Proposed Residential Subdivision

Milldale, Wainui East

# **FAST TRACK APPLICATION: SPECIALIST COMMENTS RESPONSE ADDENDUM**

Fulton Hogan Land Development Limited

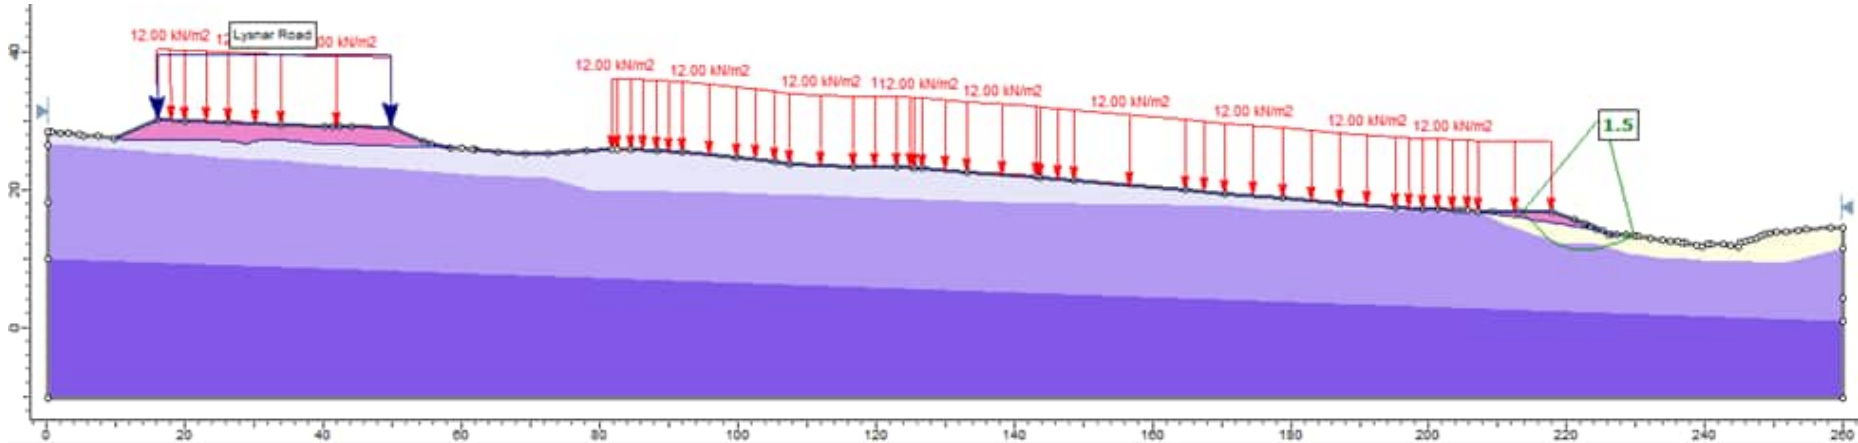
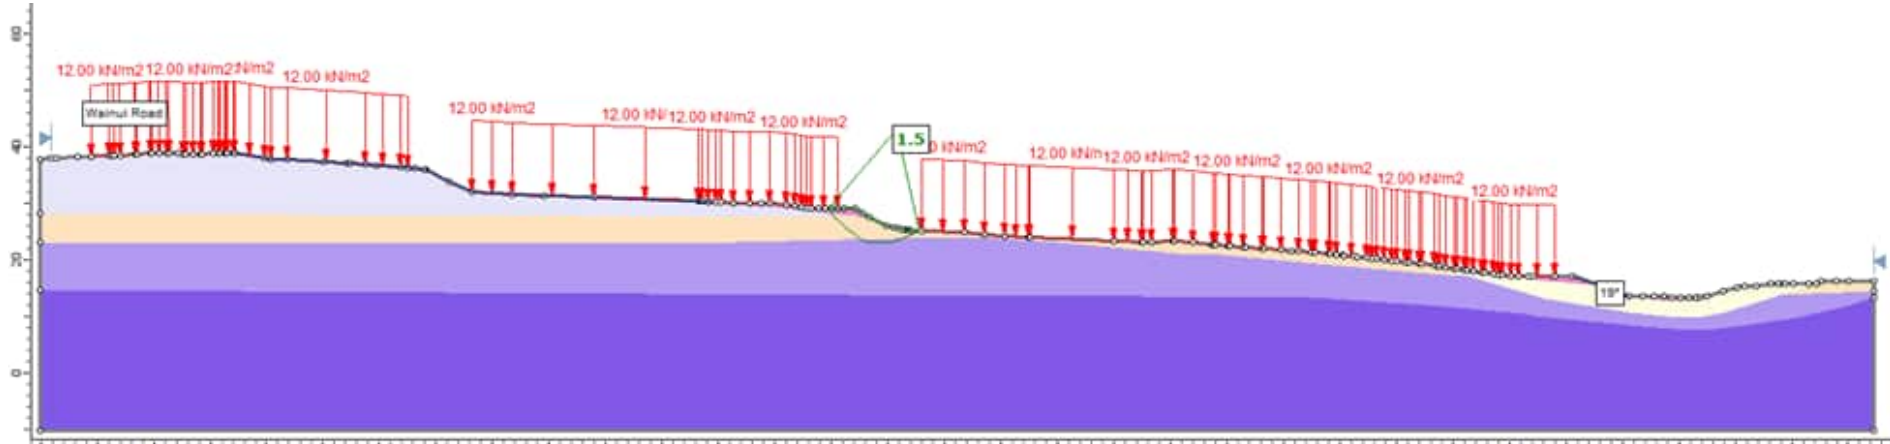
Item #	Auckland Council Comments	Final Comment to Auckland Council in Response to Item
20.1	<ul style="list-style-type: none"> <li>• Time to achieve estimated t90 settlement not stated, though this is partially addressed in the settlement memo where it stated previous stages observed time to t90 around 9 months to 1 year. We suggest that this be confirmed to aid in managing and controlling the effects of earthworks causing subsidence/instability onsite and ensure safe building platforms are achieved before 224(c) is issued following objectives and policies under E38 subdivision. We are agreeable that a settlement monitoring plan is required.</li> <li>• Note that the earthworks plan relied upon for the settlement monitoring plan in the Geotechnical Report does not align with the plan supplied by Milldale (drawings : P24-128-00-1202-EW and P24-128-00-1203-EW), a finalised settlement monitoring plan should be submitted.</li> </ul>	<ul style="list-style-type: none"> <li>• The timing between earthworks and civil works and therefore 224c typically exceeds 12 months at Milldale. We note earthworks are typically carried out across numerous stages, in most cases 1-2 years prior to civil works being undertaken. Settlement monitoring plans target critical areas (i.e. soft natural ground and deepest fills), and we generally observe the majority of settlement occurring prior to civil works commencing.  Timeframes are based on previous monitoring observed over the last 7 years of the development – we believe that settlement data provides a much better estimate of timeframes than site investigation estimates (i.e. based on correlations in CPTs etc).</li> <li>• The Settlement Monitoring Plans have been updated and are at <b>Appendix A</b>. (AKL2024-0257 DG21-22, Rev 1, 8/07/2025, shown below).</li> </ul>

Item #	Auckland Council Comments	Final Comment to Auckland Council in Response to Item
	<div><p>Extract of settlement monitoring plan from Geotech report – notice the difference in contours</p><p>Extract from Engineering drawings showing the cut fill layout (P24-128-00-1203)</p></div>	<div></div>

CLIENT: <b>FULTON HOGAN LAND DEVELOPMENT LTD</b>	DRAWN: JRS	PROJECT: AKL2024-0257
PROJECT: <b>MILLDALE - FAST TRACK APPLICATION</b>	CHECKED: MC	DRAWING: 17
TITLE: <b>REMEDIATION PLAN STAGE 10 &amp; 11</b>	REVISION: 1	SCALE: 1:3000
	DATE: 03/07/2025	SHEET: A3 L

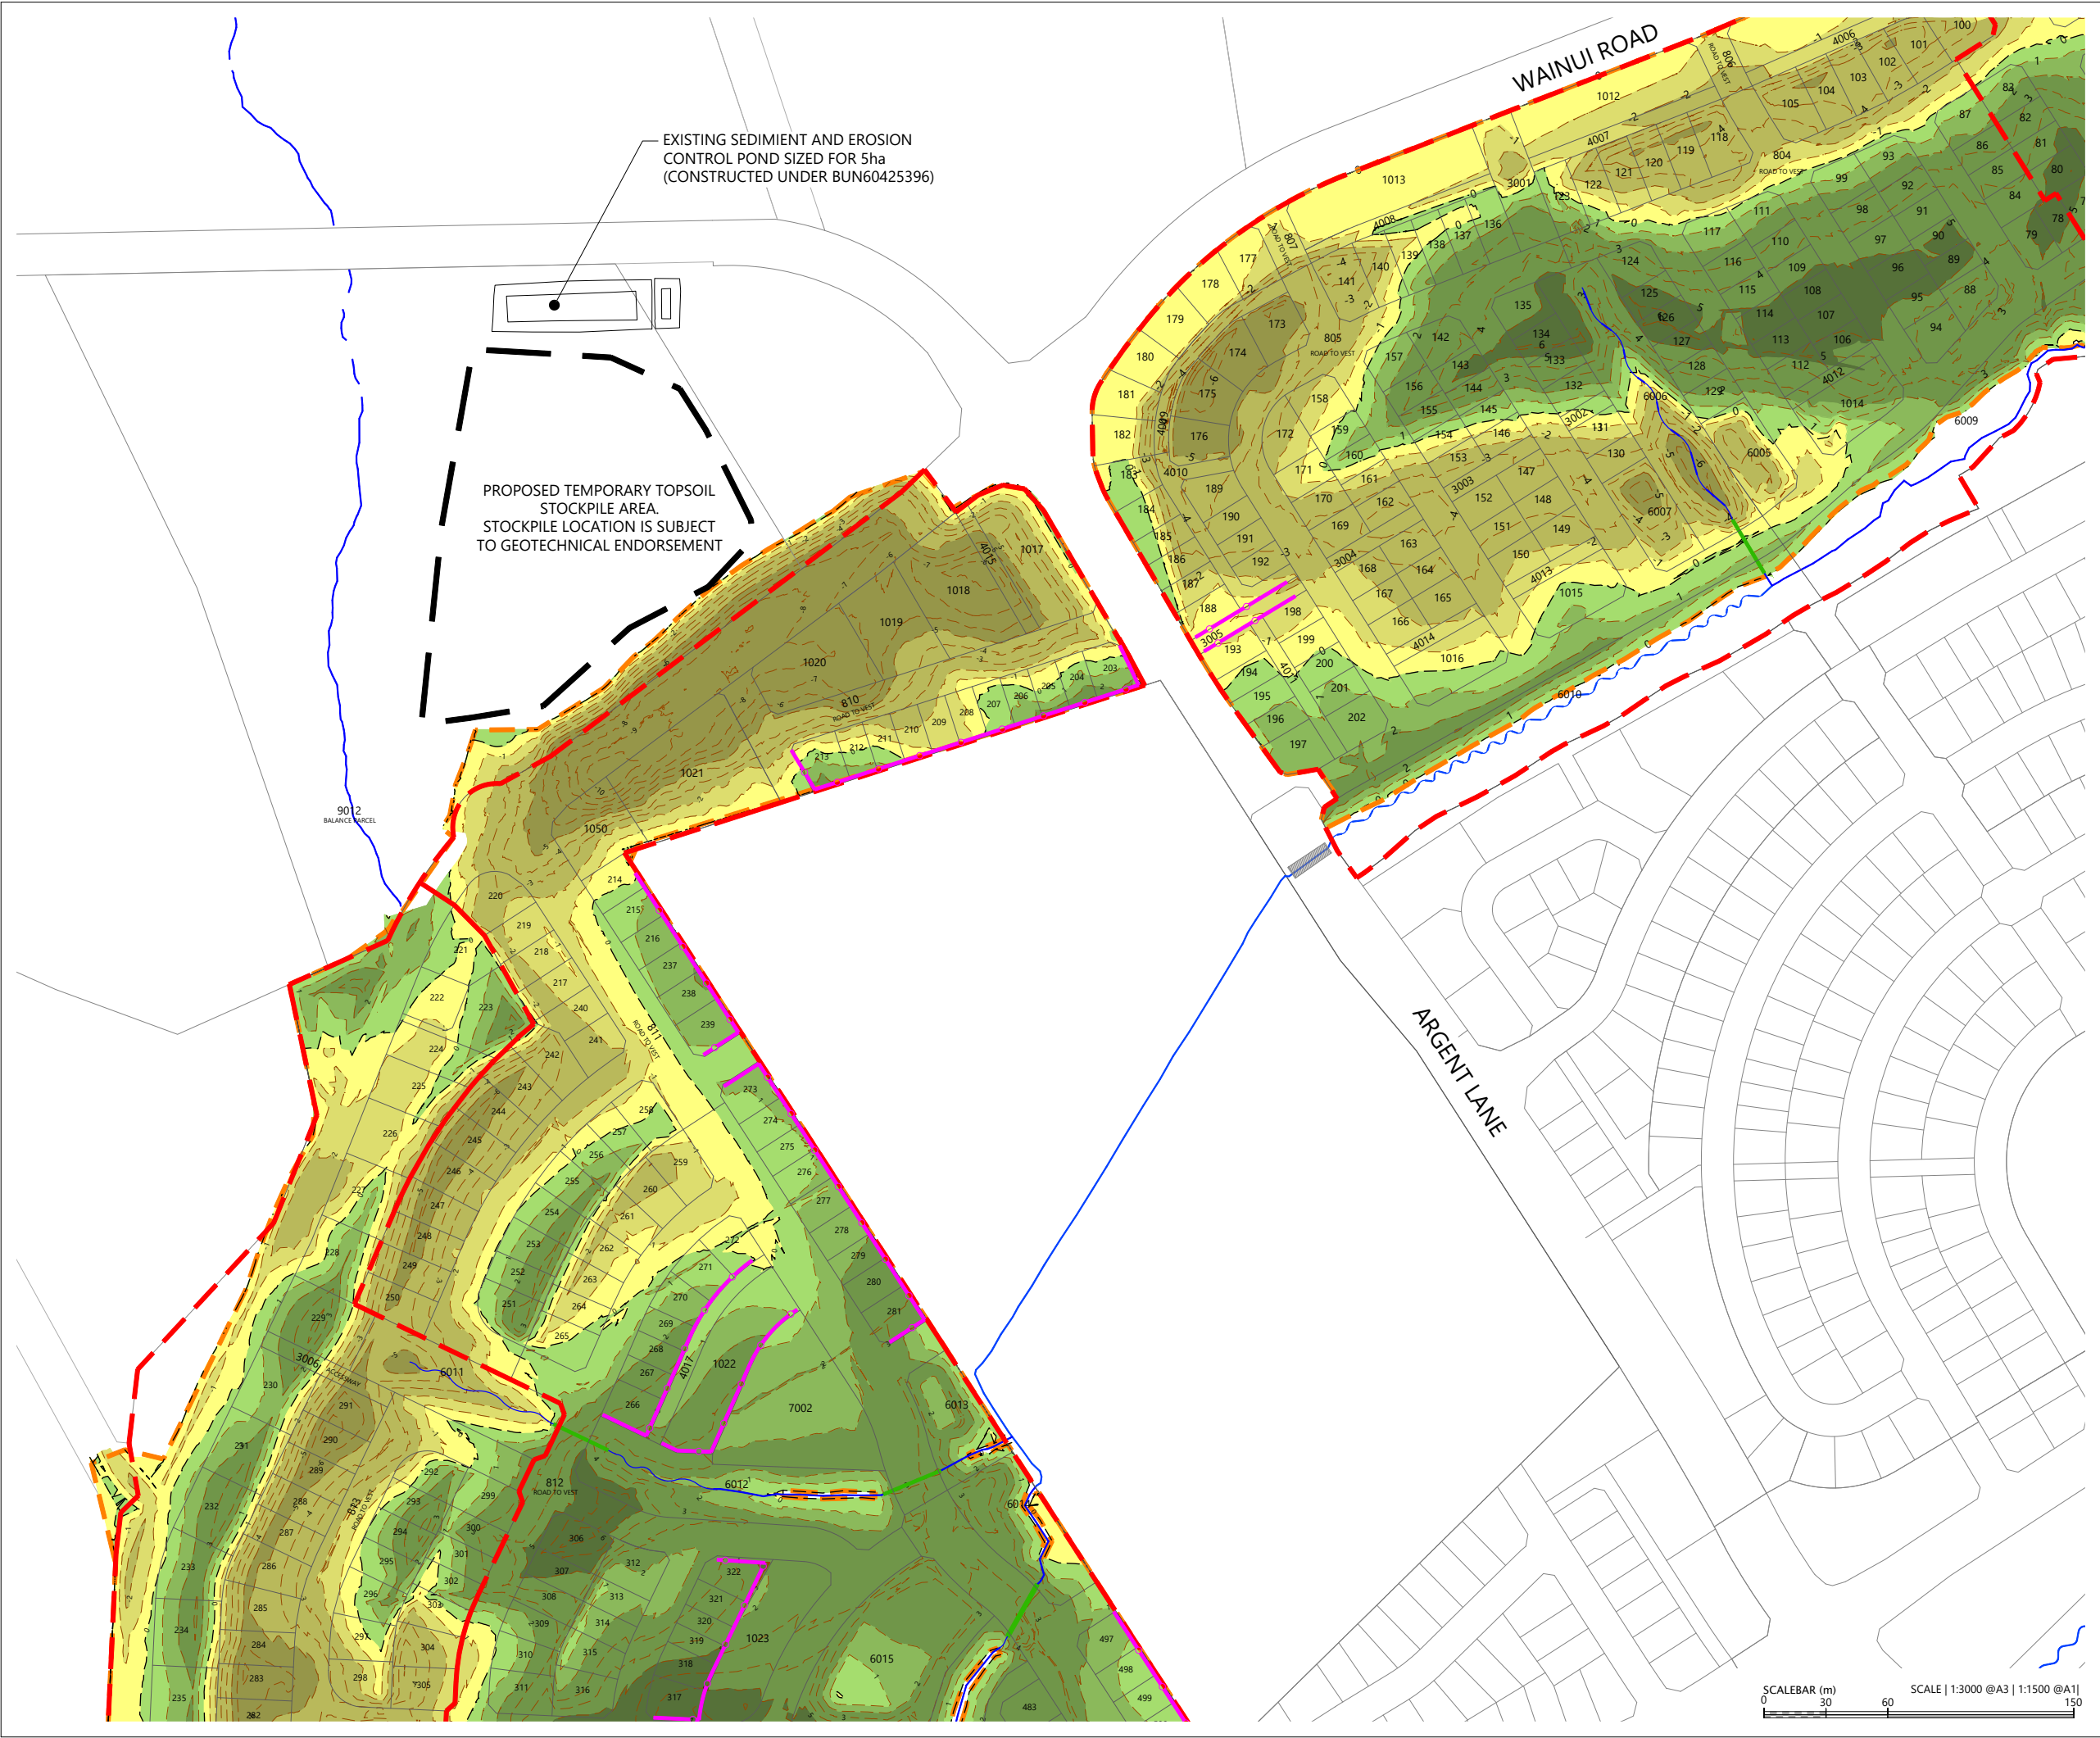
20.4	<p>There is discrepancy in the retaining wall plan where Woods Development does not show the full extent of the retaining wall in the Stage 10-11 works area where CMW considered it to be necessary and have modelled this in their slope stability outputs.</p>  <p>Site plan from geotechnical report</p>	<p>The CMW Remediation Plan, Stage 10 &amp; 11 (DG 17) has been amended (ref. AKL2024-0257 DG17, Rev 1, shown below) so that the retaining wall shown is the same as that indicated on the Woods Retaining Wall Plan.</p> <p>The palisade wall location is based on the location of the retaining wall (culvert headwall) in Woods design, we have just noted that this retaining wall will require deeper piles due to global slope instability issues.</p> <p>Further discussion on this wall is in comment 20.5. The plan is included in <b>Appendix A</b>.</p>

CLIENT: <b>FULTON HOGAN LAND DEVELOPMENT LTD</b>	DRAWN: JRS	PROJECT: AKL2024-0257
PROJECT: <b>MILLDALE - FAST TRACK APPLICATION</b>	CHECKED: MC	DRAWING: 19
TITLE: <b>UNDERFILL DRAIN PLAN STAGE 10 &amp; 11</b>	REVISION: 1	SCALE: 1:3000
	DATE: 09/07/2025	SHEET: A3 L

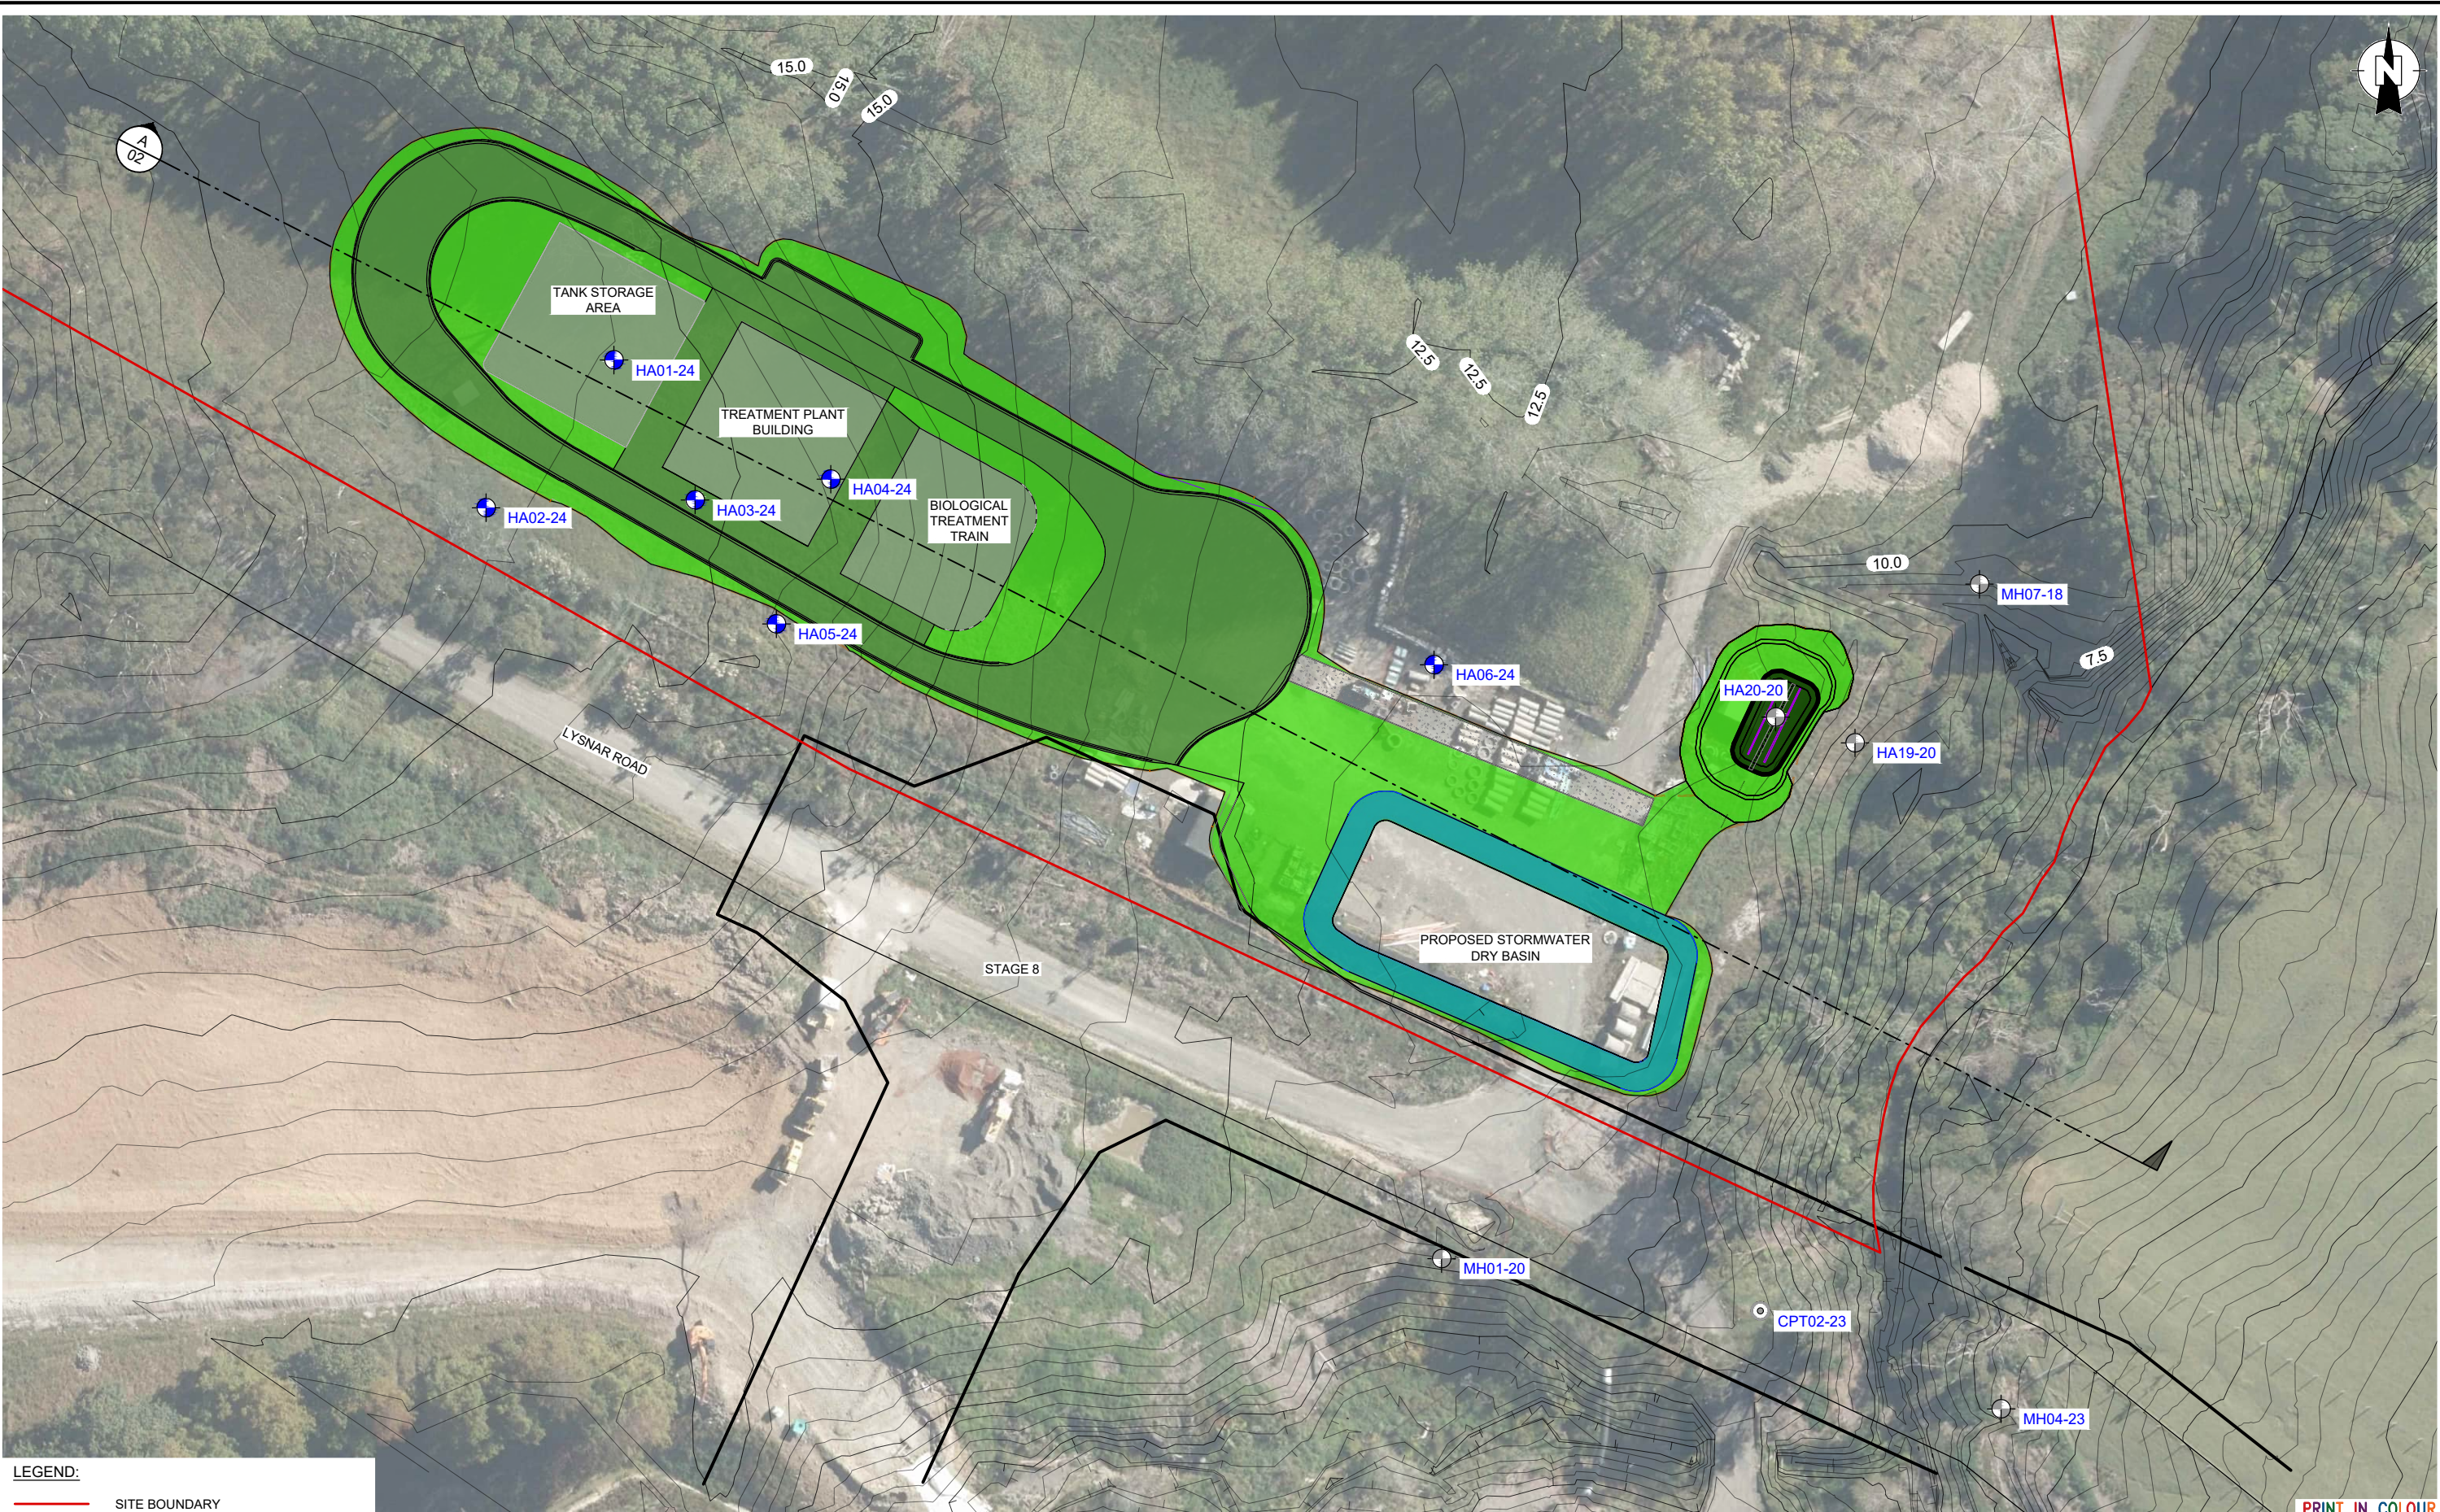
20.14	<div>Reinforced slopes shown in the Milldale plans (e.g., P24-128-00-0013-SU) are not clearly shown in the remedial slope stability analyses e.g., Cross Section A and B etc. Are reinforced slopes still required in these areas or just drainage? We also note that Sections A and B has been excluded from drawing 25 by CMW for reinforced earth batter slopes. This creates inconsistency, may alter the ground profile and development restriction zones.</div> <div></div>	<div>Our typical reinforced earth slopes only require geogrids for face creep control, not for global stability so are not shown on stability models. All reinforced engineered fill batter slopes include a drainage blanket as shown in DG 25.</div> <div>Where further remediation is required to address global stability, shear keys (below the toe of the slope) and buttress fills (beyond the minimum 4m fill width required for the geogrid reinforcing) are proposed. Sections A &amp; B do not require this remediation and as such are not listed in the tables provided in DG 25. DG 25 shown below for reference.</div> <div><table><tr><th>KEY</th><th>GRID TYPE</th><th>EMBEDMENT DEPTH L (m)</th><th>VERTICAL SPACING S (m)</th></tr><tr><td></td><td>PRIMARY</td><td>4.5</td><td>1.5</td></tr><tr><td></td><td>SECONDARY</td><td>2.5</td><td>0.5</td></tr></table><div><p>PRELIMINARY FILL BUTTRESS WIDTHS (FORMED AT 1V:2H, PARALLEL TO SLOPE FACE)</p><table><tr><th>CROSS SECTION</th><th>WIDTH (m)</th></tr><tr><td>G/G</td><td>28</td></tr><tr><td>H/H</td><td>17</td></tr><tr><td>J/J</td><td>13</td></tr><tr><td>J/J</td><td>20.5</td></tr></table><p>NOTE: FINAL BUTTRESS WIDTHS TO BE DETERMINED ON SITE BY GEOTECHNICAL ENGINEER BY MAPPING EXPOSURE</p></div><div><p>PRELIMINARY SHEAR KEY WIDTH AND DEPTHS</p><table><tr><th>CROSS SECTION</th><th>BASE WIDTH (m)</th><th>DEPTH (m)</th></tr><tr><td>G/G</td><td>18.5</td><td>5</td></tr><tr><td>H/H</td><td>17</td><td>5</td></tr><tr><td>J/J</td><td>10</td><td>6</td></tr><tr><td>J/J</td><td>14</td><td>7</td></tr></table><p>NOTE: FINAL SHEAR KEY DEPTHS TO BE DETERMINED ON SITE BY GEOTECHNICAL ENGINEER, MINIMUM EMBEDMENT INTO NORTHLAND ALLOCHTHON ROCK = 0.5m</p></div><div></div></div>	KEY	GRID TYPE	EMBEDMENT DEPTH L (m)	VERTICAL SPACING S (m)		PRIMARY	4.5	1.5		SECONDARY	2.5	0.5	CROSS SECTION	WIDTH (m)	G/G	28	H/H	17	J/J	13	J/J	20.5	CROSS SECTION	BASE WIDTH (m)	DEPTH (m)	G/G	18.5	5	H/H	17	5	J/J	10	6	J/J	14	7

Item #	Auckland Council Comments	Final Comment to Auckland Council in Response to Item
		<p>The CMW Underfill Drain Plan – Stage 10 &amp; 11 (DG 19) has been updated to include the RE slope drains in Stage 10, shown below, and included in <b>Appendix A</b>.</p>
